SAKURA EAST PRO

PLANNED REZONING OVERLAY (PRO) AGREEMENT

PLAN REVIEW CENTER REPORT

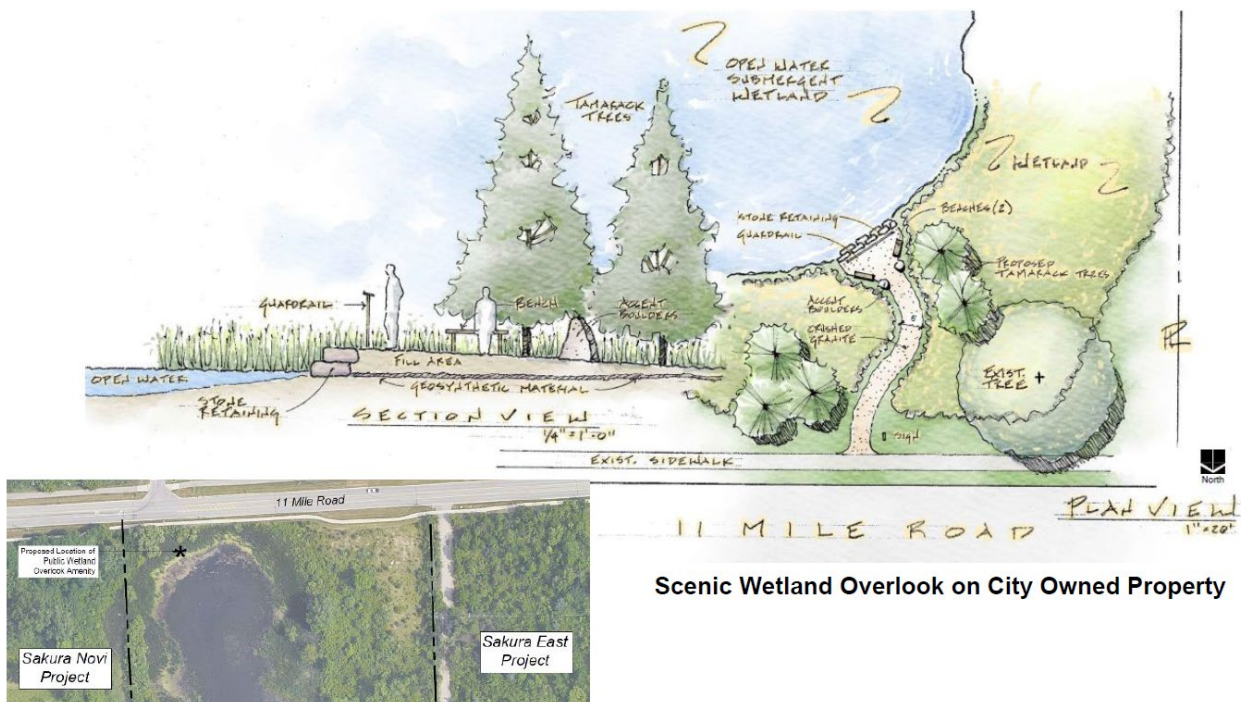
Currently the uses on the north side of 11 Mile in the I-1 District include the City's public works facility (city maintenance yard, fueling pumps, and recycling drop off) and an office complex. To the east is an office complex, the parcel to the south has a cell tower, and to the west is currently vacant City-owned land; the City has long-term plans to construct a public street generally along the parcel's west property line, connecting Grand River Avenue to Eleven Mile Road that but is not reflected on the Concept Plan. Other uses permitted in the I-1 district could replace those uses in the future. Typically, when industrial zoning abuts a residential district, a 10- to 15-foot berm is required to buffer the uses.

The PRO Plan now proposes a six-foot wooden fence along the southern property line, along with a double row of evergreen trees along most of the area. Along the eastern property line, alternating clumps of arborvitae and large evergreen trees are proposed to provide screening to the adjacent office complex. Rezoning to residential will have impacts on the surrounding properties, which will face additional scrutiny to develop, larger setbacks and new buffering requirements. The screening burden should be shouldered by the applicant, which is creating the non-compatibility, however given the small site there is little room to provide berms. The Town Center Area Study recommends masonry screening walls, which is what is being installed in the Townes at Main Street development that is under construction. Similar 6-foot masonry walls should be considered at this location to provide screening from the Industrial zoned properties, except where it would conflict with the preserved wetland.

Attachment B
Site Photographs

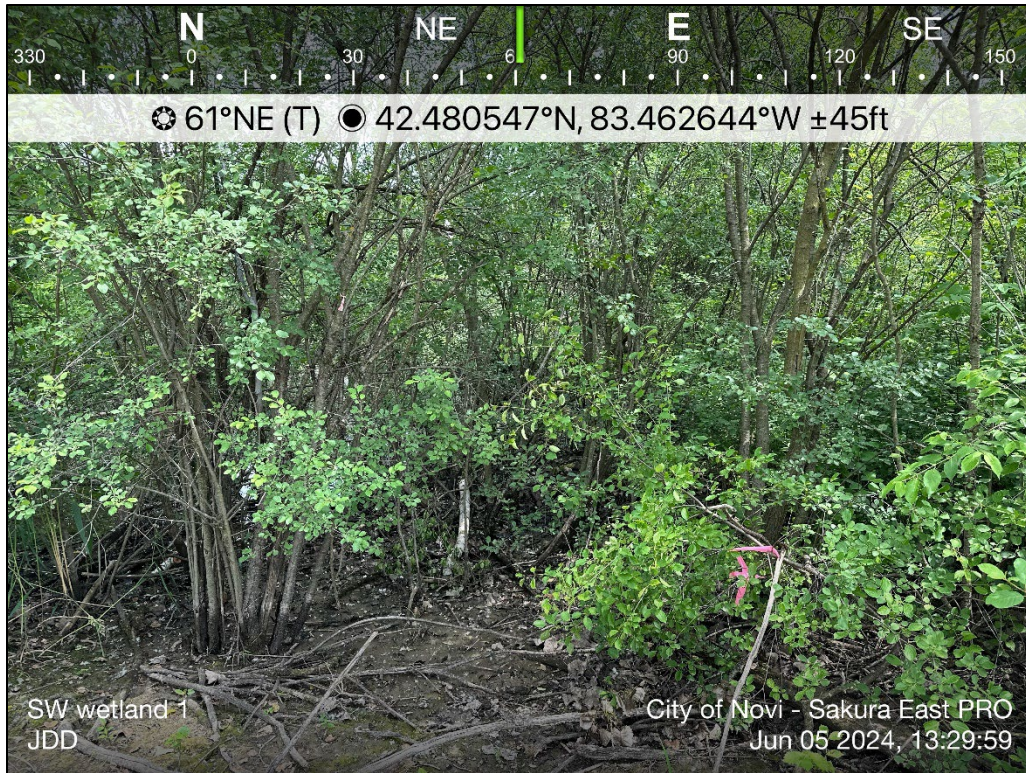
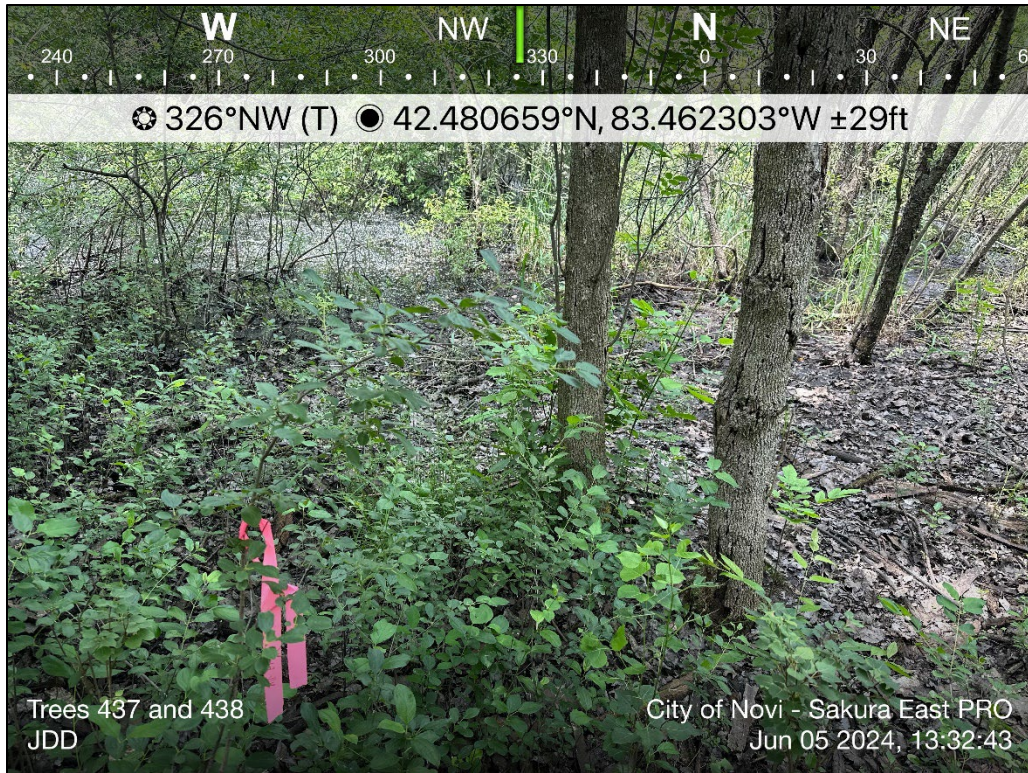
1. As stated above, Merjent conducted a site visit on May 15, 2024. In the November 8, 2023 review, MSG requested that the wetland boundary be expanded to include trees 423, 424, 436, and 437. Merjent concurs with MSG's recommendation and drawing P-3 displays a modified wetland boundary encompassing trees 436 and 437. However, the flagging on-site nor the provided PSP appear to encompass trees 423 and 424.

Overview of Trees 423 and 424. Note the pink flagging in the background behind the two trees.

Overview of Trees 436 and 437 with the adjusted pink flagging.
